SITE SUPPLEMENTAL INSTRUCTION

PROJECT: Forestside Estates
Attmar & Palleschi Drive
Brampton, ON

SITE SI NO. M-2

PURPOSE: To revise mechanical layout to suit architectural SI A-01 and City comments.

DRAWN	CHECKED	SCALE
MC	LM	1:150
DATE	PROJECT	DRAWING
MAY, 2019	18-017	M-3
		OF

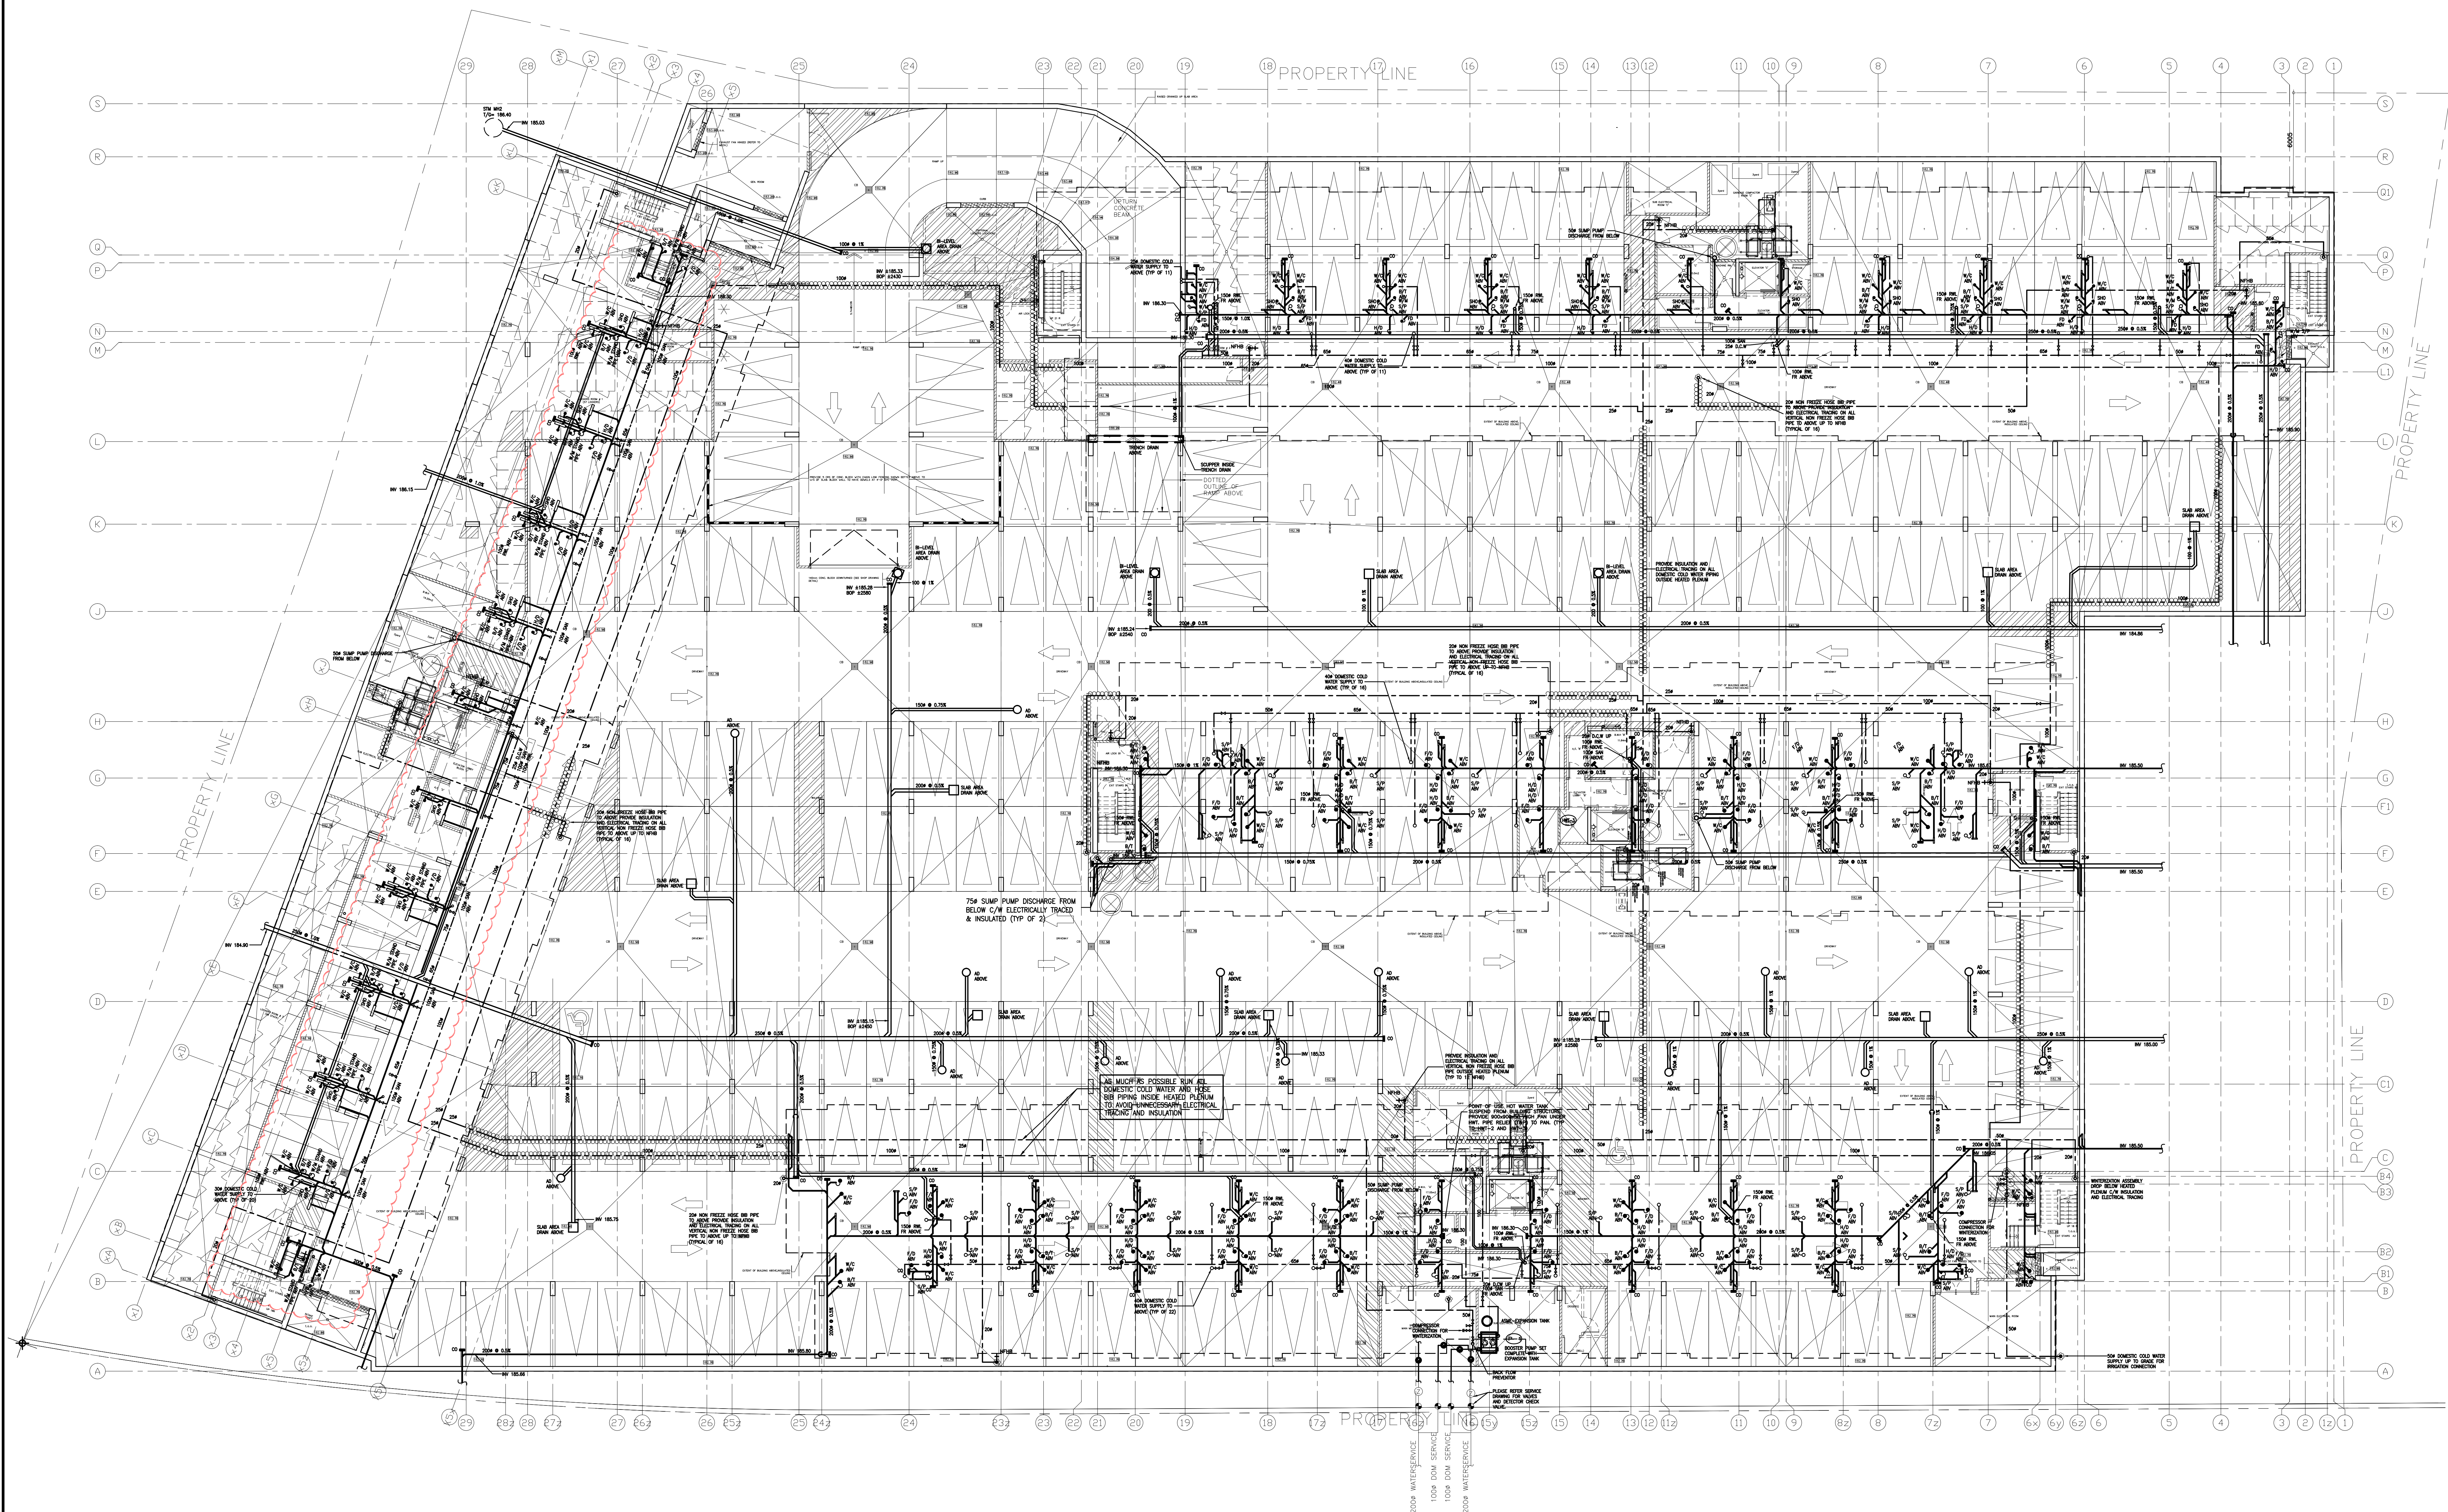
1.0 Reference Drawing M-3, M-3A, M-3B (Plumbing P1 - Mechanical) Issued

1.1 Revised: Mechanical layout to suit Arch site instruction.

DRAWN	CHECKED	SCALE
MC	LM	1:150
DATE	PROJECT	DRAWING
MAY, 2019	18-017	M-4
		OF

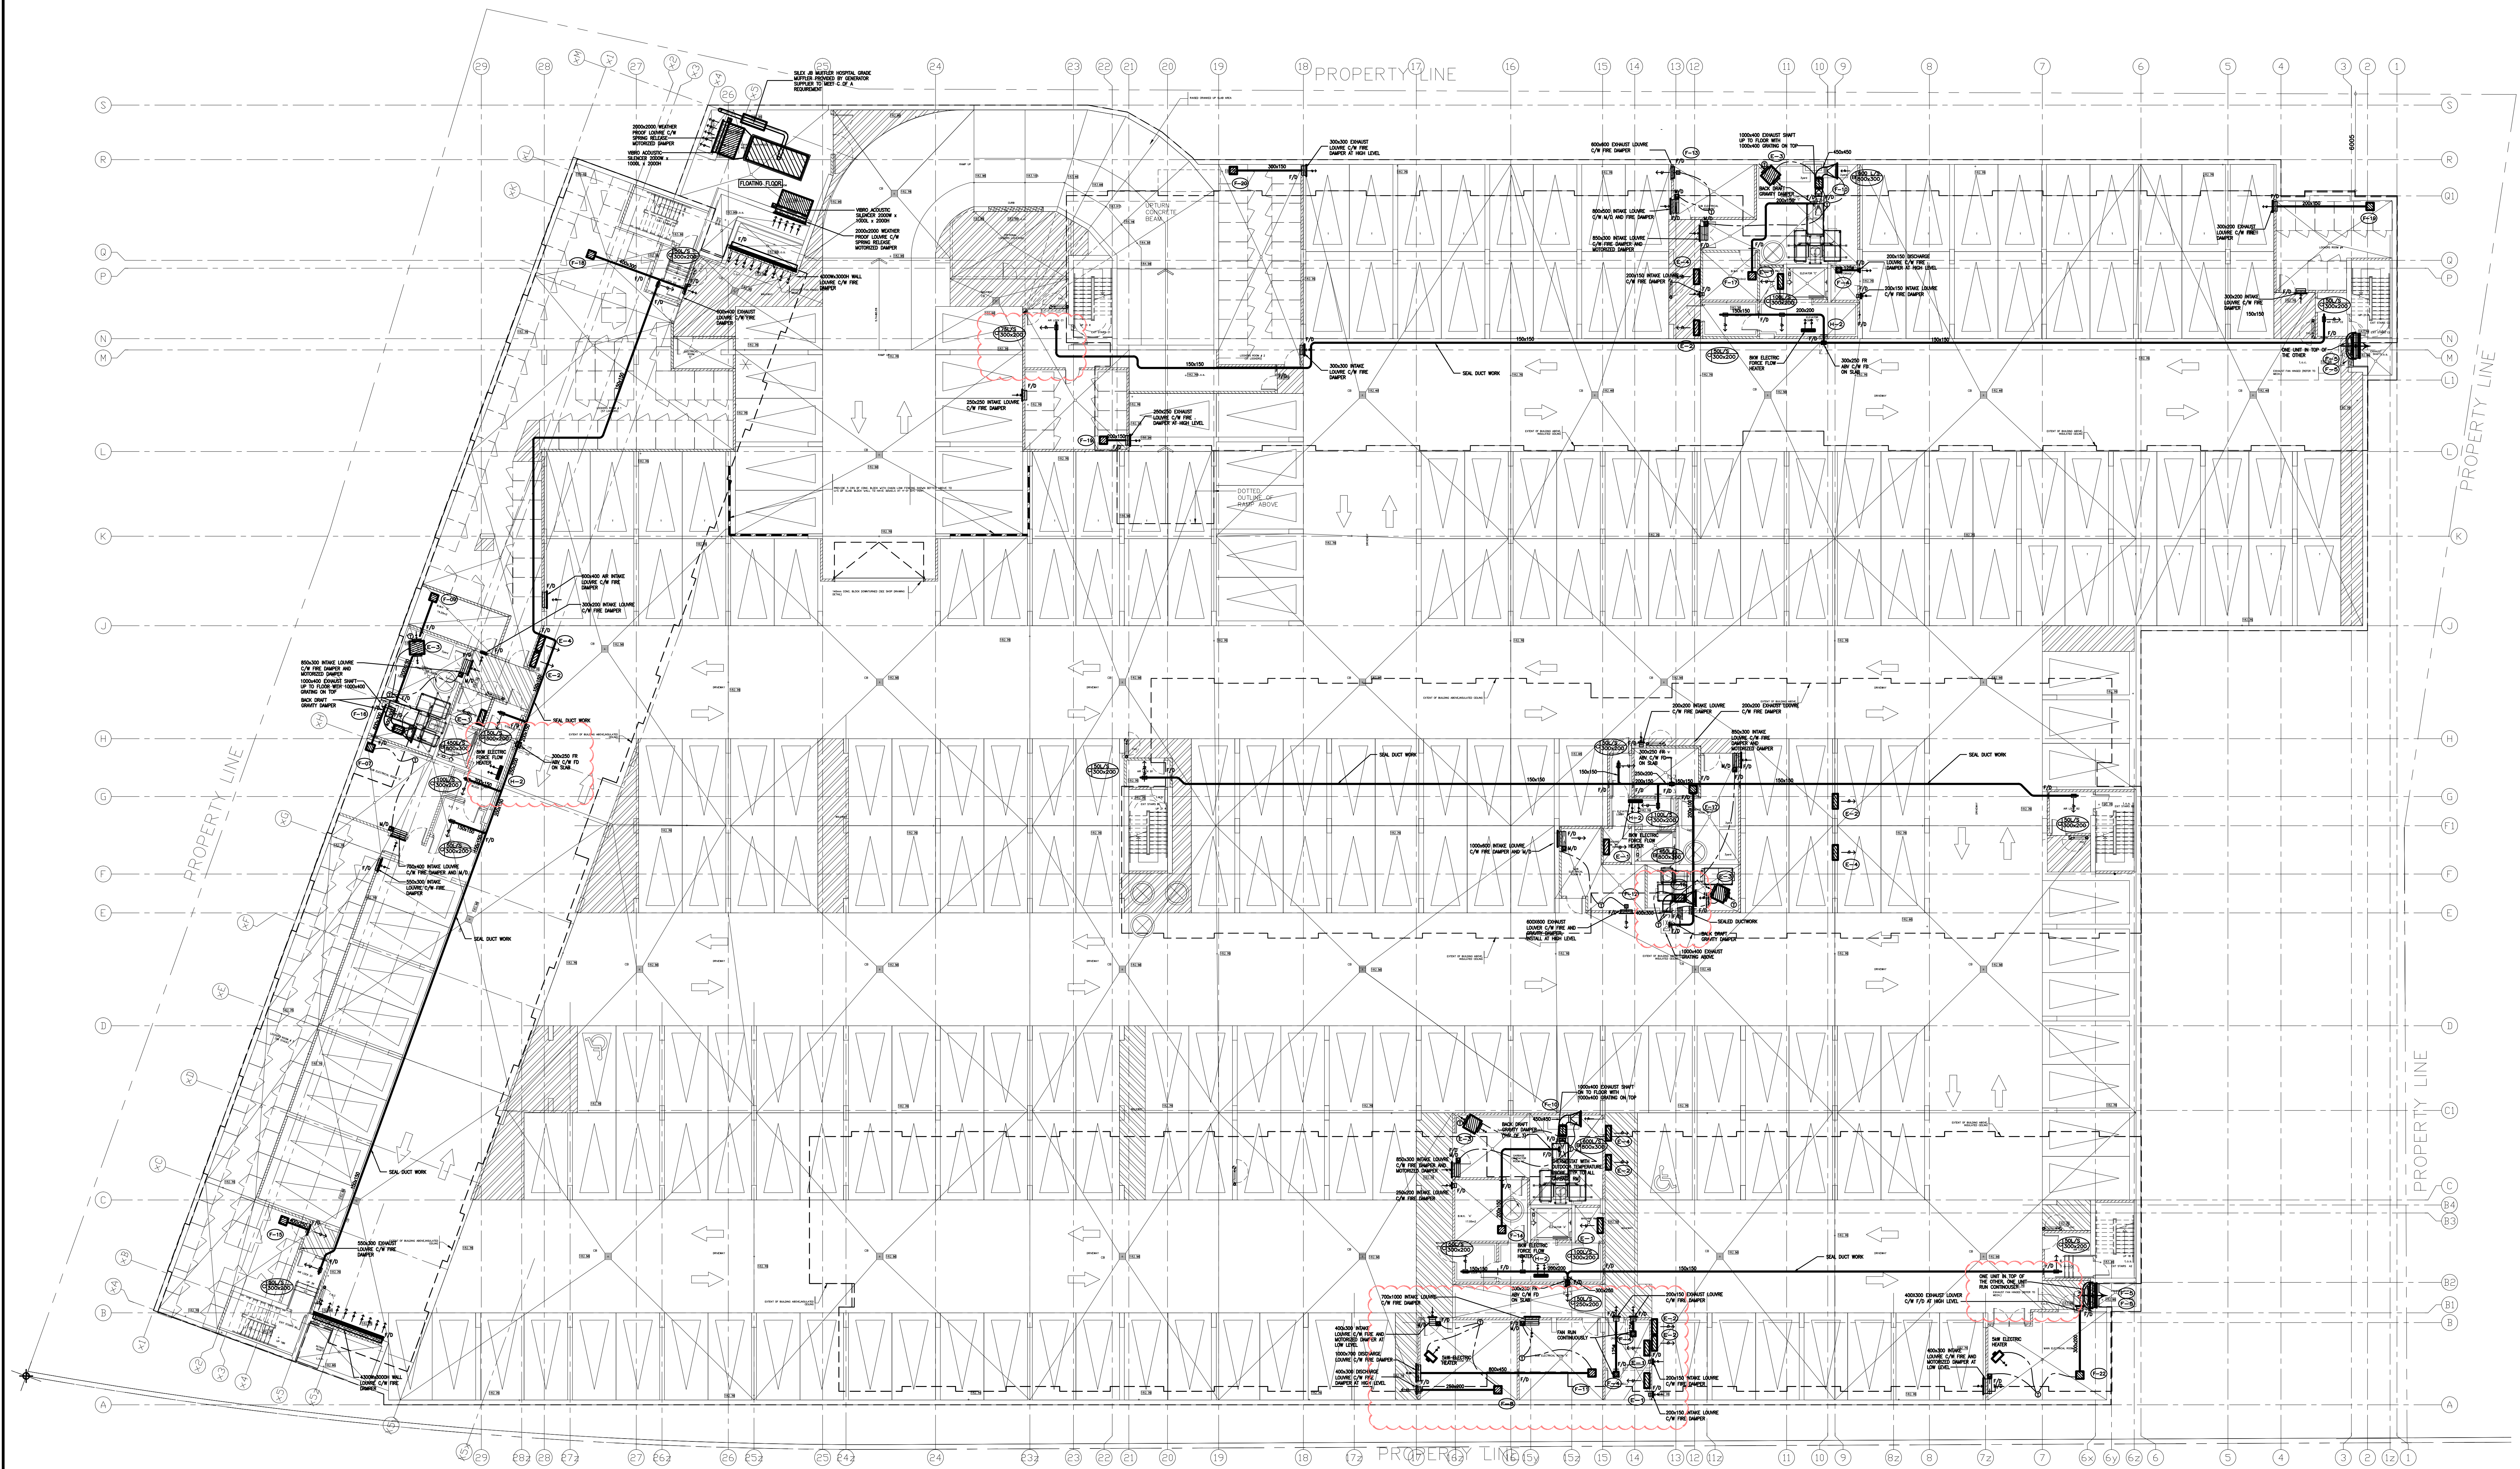
2.0 Reference Drawing M-4, M-4A, M-4B, M-4C (HVAC GAS - Mechanical) Issued

2.1 Revised: Building D gas pipe layout to suit Arch site instruction.

2.2 Clarify: Building D fresh air shaft location.

2.3 Revised: Air lock diffuser location and volume.

2.4 Relocated: Building B F-16.

2.5 Relocated: Intake louver at sub electrical room 'A'.
